Akron Manual Valve Actuator PB-128804

PRODUCT NAME: Manual Valve Actuator

STYLE NUMBER 8620, 8625, 8630, 8635

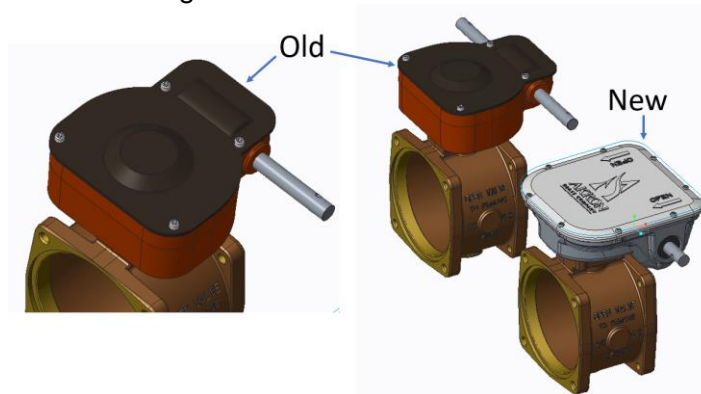
In July Akron transitioned to a new style of manual actuator. The new actuator allowed the manual valve actuator to match the new electric actuator.

- New bearing for smoother operation
- Components offer a better watertight seal
- Dual shaft operation as standard
- Lower weight

- Be aware the new ratio is 14:1 instead of 12:1 creating issues for ratio specific handwheels. The change in ratio does not cause any issues with Akron's position indicating handwheels.
- New dimensions of the handwheel shown on second page. Old style shown on left and new style on right.
